SUZUKI MOTOR OF AMERICA, INC.

IMPORTANT SAFETY RECALL

In July 2015 Suzuki notified owners of 2006 - 2015 Suzuki VZR1800 (Boulevard M109R) motorcycles of a safety recall certain Suzuki Genuine Accessory backrest mounting hardware kits (Part Number 990A0-75148 or Part Number 990A0-75148-BLK). These mounting hardware kits may have been used to install accessory backrests on 2006 - 2015 VZR1800 (Boulevard M109R) motorcycles.

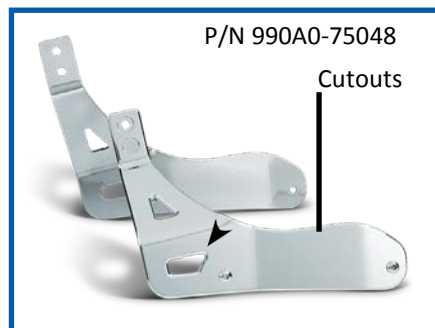
The mounting hardware for installing the Suzuki Genuine Accessory backrest P/N 990A0-75148 and P/N 990A0-75148-BLK on 2006 - 2015 Suzuki VZR1800 (Boulevard M109R) motorcycles may contain mounting bolts which are an incorrect length. Under certain loads and riding conditions, it may be possible for the mounting bolts to contact the rear tire, damaging it and/or causing loss of control, increasing the risk of a crash.

Because it is equipped with incorrect four 110mm mounting bolts — these bolts must be replaced with correct 75mm (two) and 95mm (two) mounting bolts.
